**BEFORE PALMERSTON NORTH CITY COUNCIL**

**IN THE MATTER OF** a proposed plan change to rezone land at 611 Rangitikei Line to  
establish the Whiskey Creek Residential Area

**JOINT WITNESS STATEMENT OF PLANNING WITNESSES IN RESPONSE TO MINUTE 3 OF INDEPENDENT  
HEARING PANEL**

### Map 22.6.3 Flood Prone Overlay: Whiskey Creek Residential Area

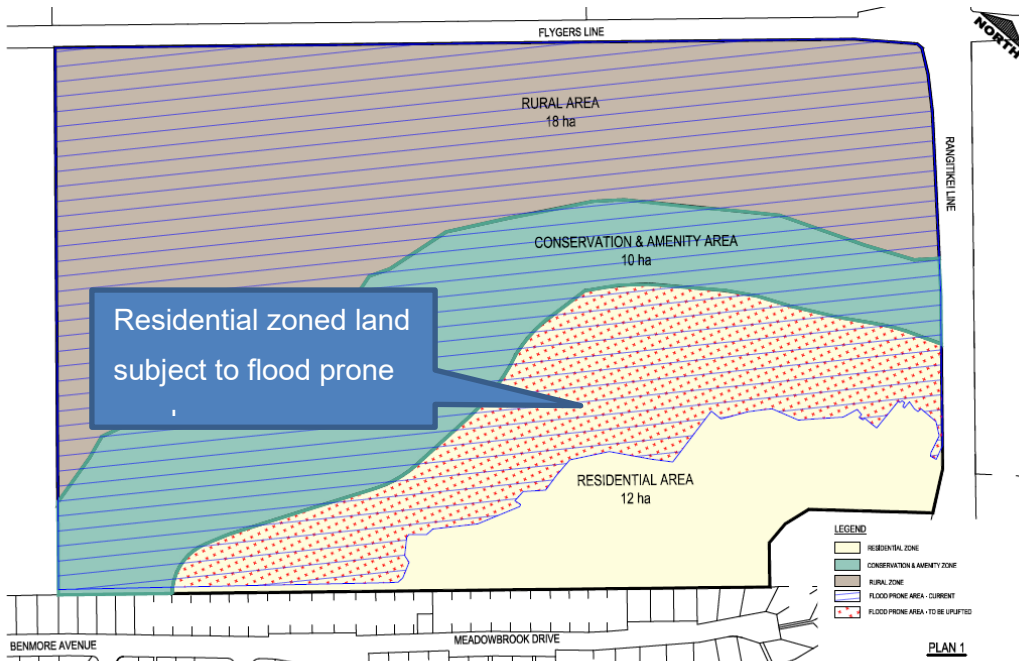
- [5] This matter relates to how and when the flood prone overlay on the District Plan maps is amended once earthworks are certified.
- [6] It is agreed that once the land is not flood prone the Plan Maps should be amended to reflect this. However, the mechanism to implement this is not agreed. For the reasons set out in paragraph 11 – 16 Mr Duindam and Mr Asgar are of the opinion that this should be actioned through a future Council led Plan Change (either stand alone or part of a separate Plan Change) once the works are actually done and the land is no longer flood prone.
- [7] Mr Thomas is of the opinion that a valid mechanism can be inserted to the Plan as part of this plan change process. He recommends the insertion of an additional Map to Section 22 Natural Hazards

showing the extent of the change together with text as to what is required for it to take effect. A draft is set out below.

- [8] The map above shows the zones and the flood prone overlay within the area to be uplifted shown clearly shaded. It should also be noted that “flood hazard avoidance” is already defined in the District Plan and adopts the One Plan definition.

- [9] Mr Thomas considers this is clearly a s32 evaluation matter. Mr Thomas considers that his approach provides certainty and least cost. It avoids any other plan change process and is therefore more efficient with less cost and uncertainty over timing.

- [11] Mr Asgar and Mr Duindam have concerns around the uncertainty with the approach presented by Mr Thomas, as there is room for error with many unknown factors. It is unclear under the proposed provision who is responsible for determining whether ‘flood avoidance’ has been achieved in order to trigger the Flood Prone Overlay removal, as it seems to require the application of an expert opinion or judgment.

- [13] Mr Asgar and Mr Duindam prefer that the final outcomes from the earthworks consent have been achieved prior to removal of the overlay. The Council considers it would not be best planning practice to have a Map recording a flood hazard overlay that is subject to removal based on a trigger that is not sufficiently certain, and which assumes a future state which is also not sufficiently certain.

- [14] Mr Asgar and Mr Duindam notes further that the proposed provision “deems” the land to no longer be subject to the Flood Prone Overlay, but it does not actually have the effect of changing the Flood Prone Overlay maps. This would be confusing for plan readers and would not be the most efficient or appropriate way to deal with the issue. Accordingly, even if Mr Thomas’ recommended provision was accepted, the Council would still need to fix up the Flood Prone Overlay maps in a future plan change, so there is in effect no planning efficiencies created by the proposed trigger rule.

Map 22.6.3 identifies an area that is zoned Residential and also shown on the Plan Maps as Flood Prone Area. If Flood Hazard Avoidance is achieved for that area, then it shall be deemed to immediately cease being Flood Prone Area, despite anything to the contrary in the Planning Maps.

- [15] As such, Mr Asgar and Mr Duindam have proposed to retain the Flood Prone Overlay as originally recommended within Mr Asgar’s evidence. Once flood avoidance and stormwater mitigation has been achieved to Council satisfaction following earthworks, Mr Duindam has assured that Council will take it on themselves to undertake a future Plan Change seeking to remove the Flood Prone Overlay from within the new Residential Zone. This could occur in any one of the Council’s several upcoming plan changes, subject to the works actually being completed.
